WestConnex M4-M5 Link

Rozelle Interchange - Modification: The Crescent overpass and active transport links

Response to submissions on the Design amendment report

June 2020

Figure 2-1: Space for pedestrian and cyclists at The Crescent crossing

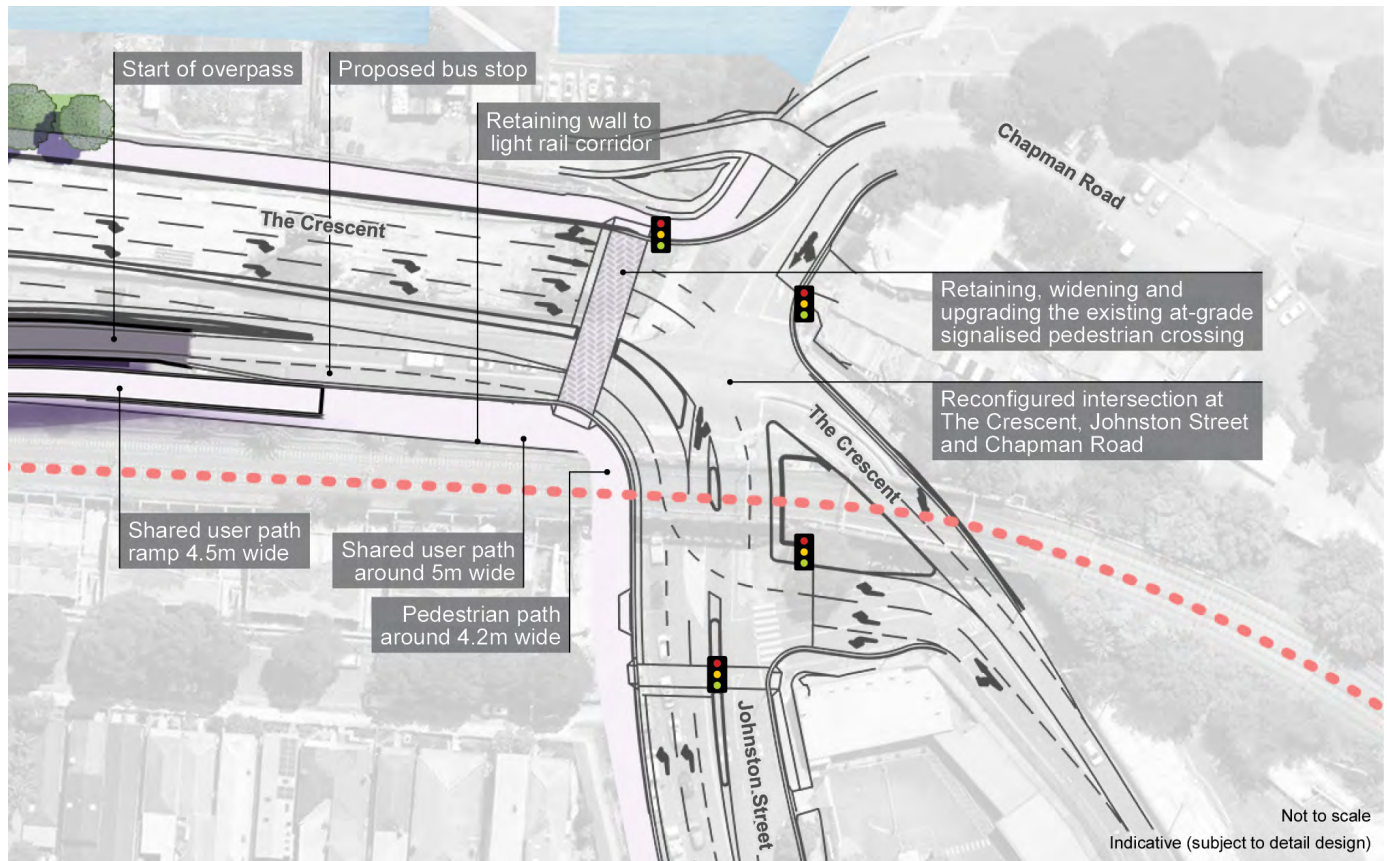
The revised design will potentially result in large groups of people including school groups, families, scooters and bicycles waiting on the corner of Johnston Street and The Crescent. Meanwhile access from Railway Parade to the foreshore at street level will require three road crossings beneath the elevated structures among freeway like roads.

The City notes that retaining the northern pedestrian crossing on The Crescent and widening the crossing to six metres is an improvement on the EIS and Modification 2.

The revised design proposes a widening of the pedestrian space adjacent to the north west corner of the intersection of The Crescent and Johnston Street (refer **Figure 2-1**). On the west side of The Crescent the pedestrian space between the mural and the road pavement will be widened from around 3.5 metres to five metres in the area adjacent to the crossing. On the north side of Johnston Street under the light rail bridge the pedestrian path between the bridge abutment and the road pavement will be widened from around 3.5 to 4.2 metres in the area adjacent to the crossing. As a result, there will be an increase in space available for pedestrians and cyclists at this corner of the intersection.

The revised design proposes a widening of the pedestrian space adjacent to the north west corner of the intersection of The Crescent and Johnston Street (refer **Figure 2-1**). On the west side of The Crescent the pedestrian space between the mural and the road pavement will be widened from around 3.5 metres to five metres in the area adjacent to the crossing. On the north side of Johnston Street under the light rail bridge the pedestrian path between the bridge abutment and the road pavement will be widened from around 3.5 to 4.2 metres in the area adjacent to the crossing. As a result, there will be an increase in space available for pedestrians and cyclists at this corner of the intersection.

Figure 2-2 Revised design - pedestrian and cyclist active transport connections

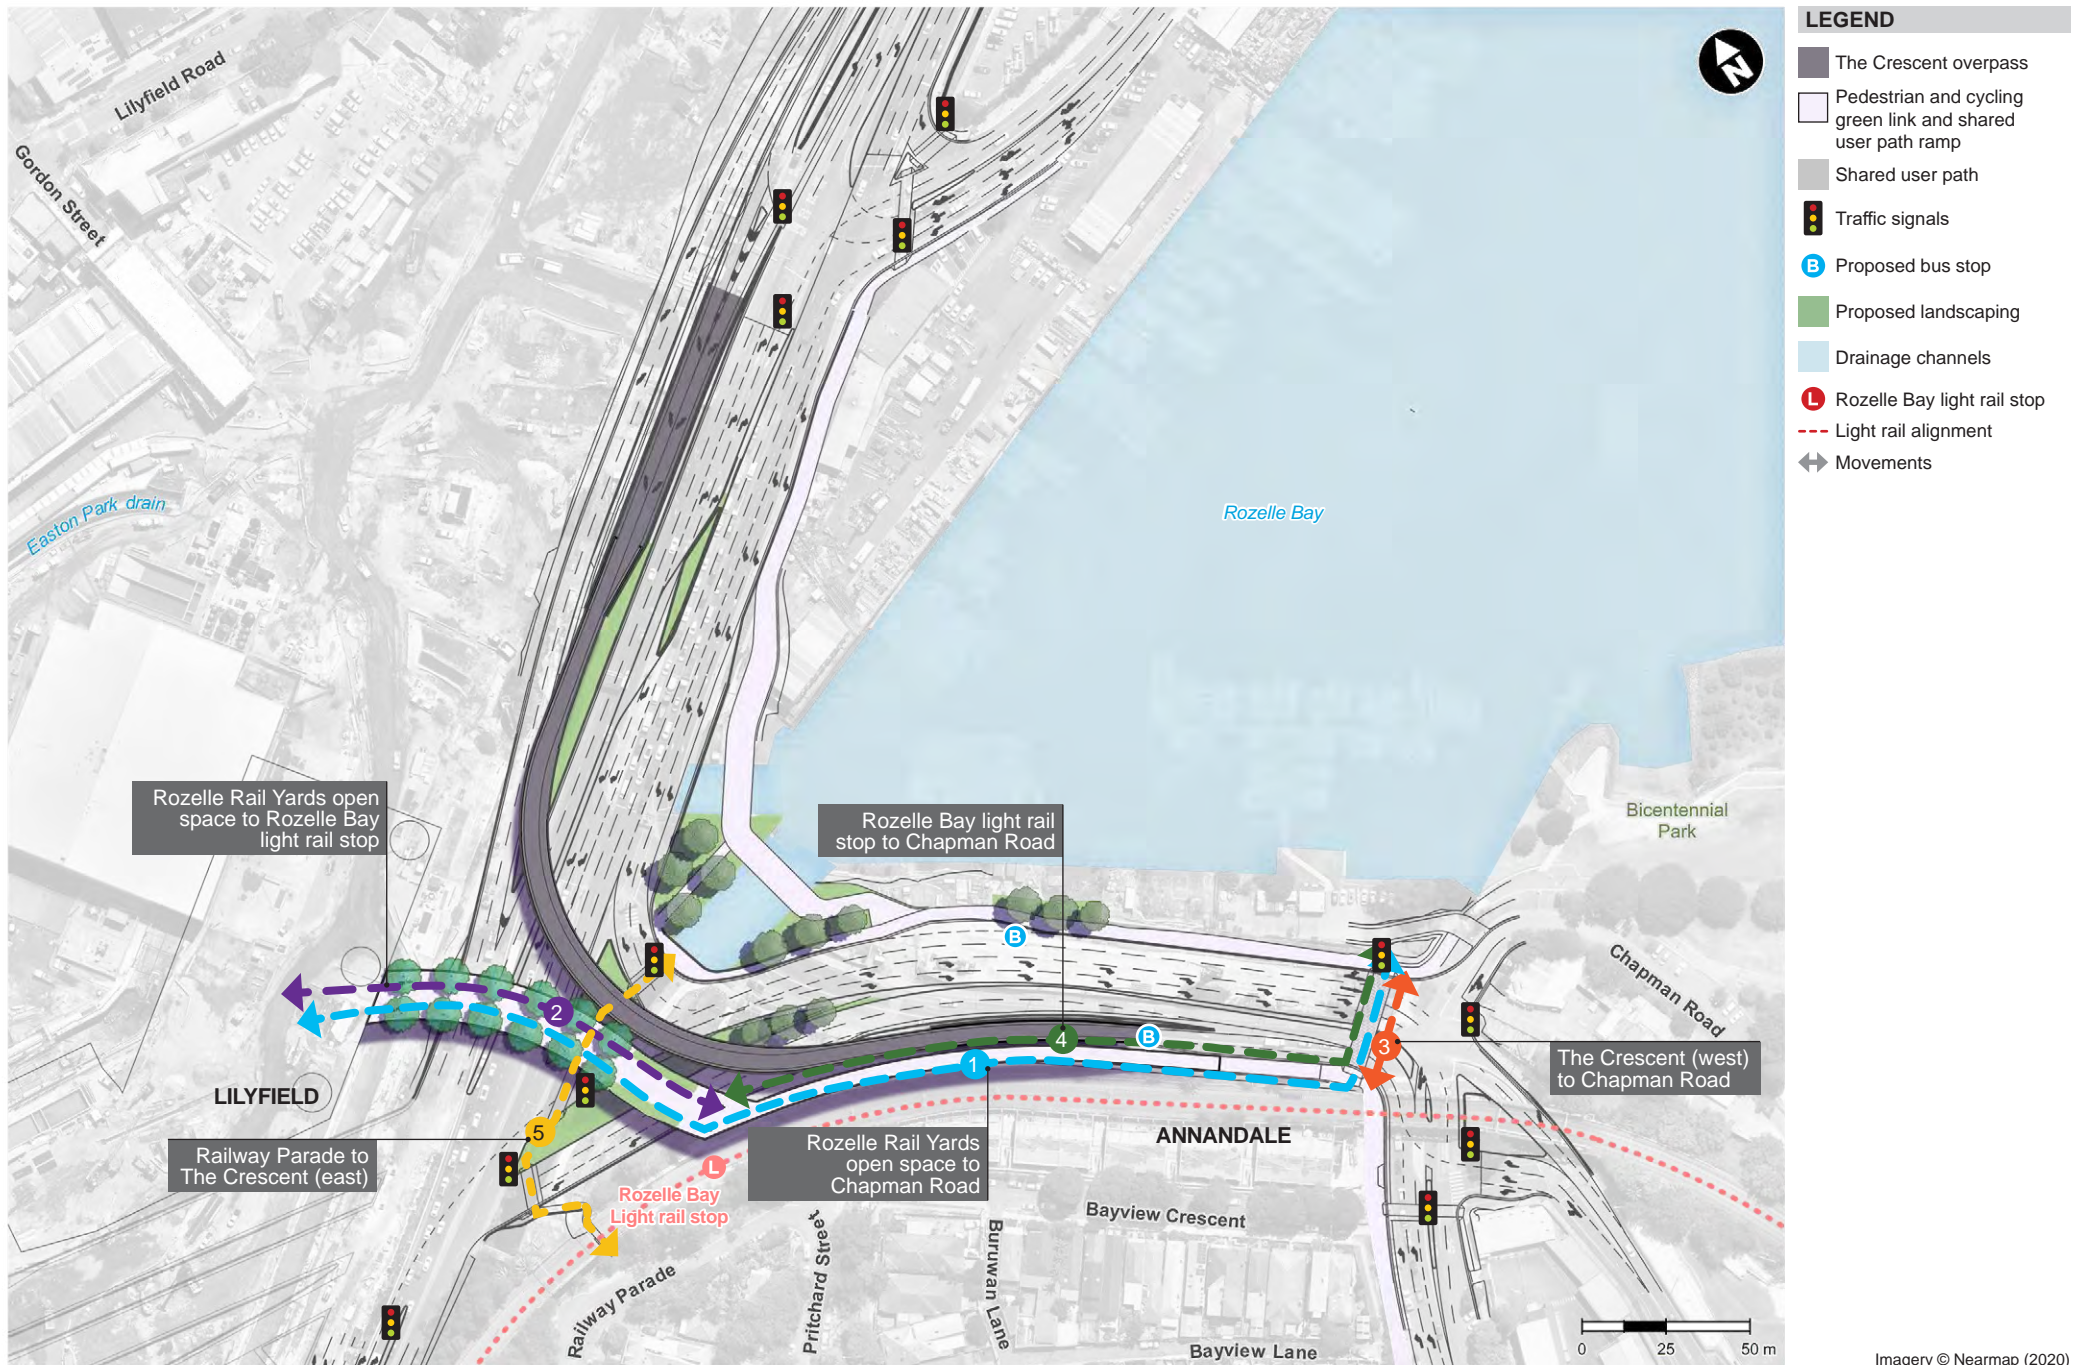
...many underlying issues with the previous design (resulting from the introduction of the vehicle overpass) are still prevalent in the latest version. The City's concerns raised in its submission on the original Modification 2 remain valid for the Modification 2 Design Amendment. It will:

The alternative route is slightly longer in distance (365 vs 330 metres) and travel time (05:56 vs 4:14 minutes) by comparison to the EIS but reduced in distance (365 vs 515 metres) and travel time (05:56 vs 6:36 minutes) by comparison to the arrangements proposed in the Modification report. Calculated pedestrian travel distances and times for each section of the active transport connections are detailed in **Table 2-1**. The calculated travel times include waiting times at signalised intersections and are based on an average pedestrian walking speed of 1.3 metres per second. The active transport connections are shown on **Figure 2-2**.

Figure 2-3 Indicative elevation: The Crescent mural

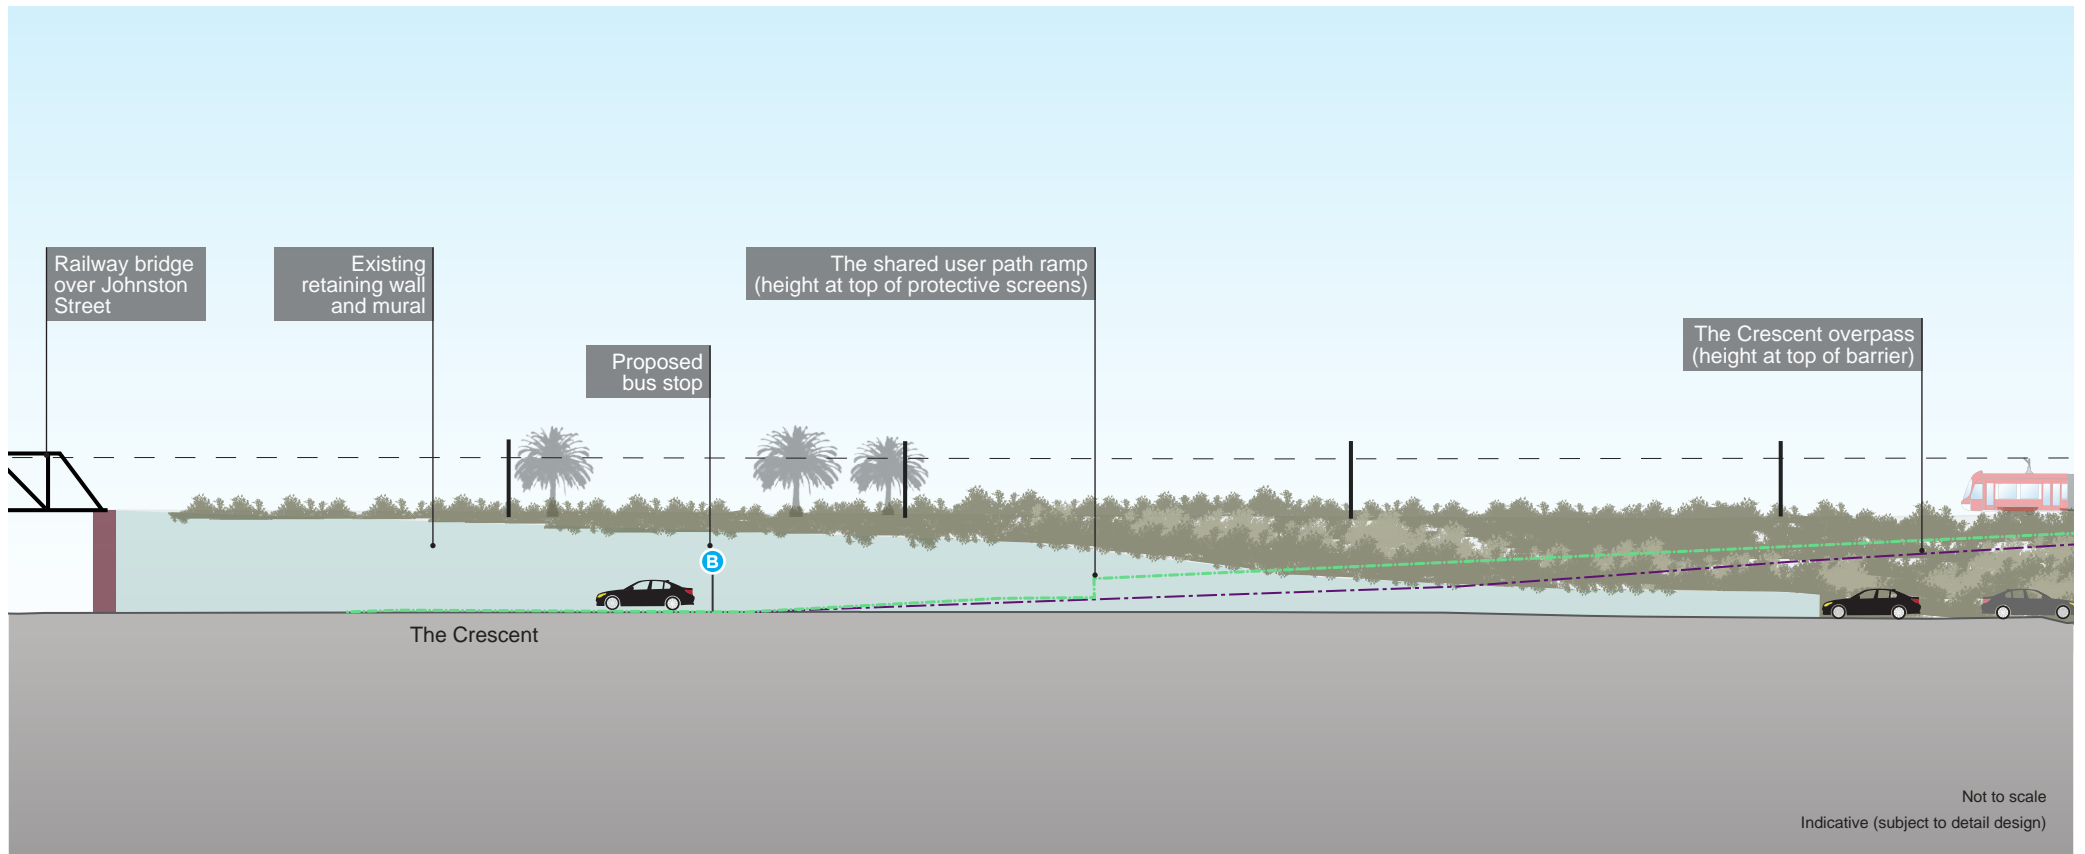
Matter	Section where addressed in the Response to submissions report (April 2020)	Further clarification
<i>The overpass will obstruct the view of the mural and would result in an increased impact by comparison to the EIS design.</i>	Section B2.1 Section B2.5 Section B2.6 Section C10.1	Along the west side of The Crescent the shared user path ramp and overpass would impact on views from motorists, pedestrians and cyclists toward the northern section of the existing mural, however, views to the central and southern sections of the mural would not be impacted. In the EIS there was a pedestrian ramp proposed in this same location which would have a similar impact on views to the mural (see Figure 2-3). For further information see Section 3.6 of the Design amendment report.
Contamination		
<i>No substantiation that the tunnel option would encounter contaminated materials beyond what would be encountered in the overpass option.</i>	Section B2.4 Section C.4.1 Section C9.2	Contamination impacts within the footprint of the proposed modification were assessed in Section 6.10 of the Modification report. The tunnel option would involve excavation over a distance of around 400 metres. By comparison the overpass option would involve limited excavation for foundations and piling at discrete locations along the alignment of the overpass. As a result, the tunnel option would be more likely to encounter contaminated materials over a wider excavation footprint, by comparison to the overpass option.
